MONTGOMERY COUNTY HEALTH DISTRICT  
APPLICATION FOR INSPECTION & PERMIT TO INSTALL SEPTIC SYSTEM

DATE 5-30-82 FEE PAID 75.00 xx PERMIT NUMBER 01003

LOCATION OF PROPERTY TO BE INSPECTED: Turtle Creek Blk 2 Lot 5 Turtle Creek Ln

FINAL INSPECTION DIAGRAM

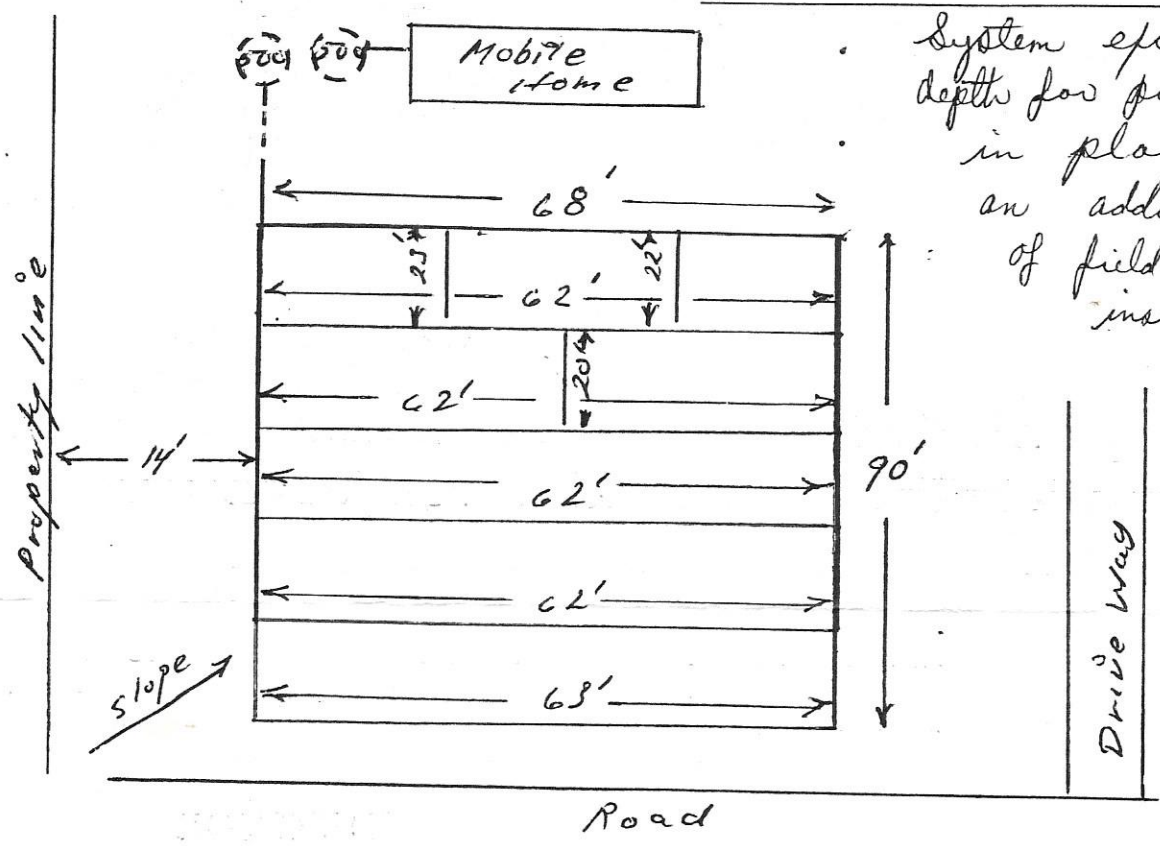
System exceeds trench depth for partial E.T. in places. However an additional 268 sq. ft. of field line was installed over the requirements. System meets standards with the above comments noted.

COMMENTS: P.V.C, 20", Gravel, 12", Hay, Dry Slopes to the back of the lot (1-6")  
Trench was deeper in places due to the slope of lot.
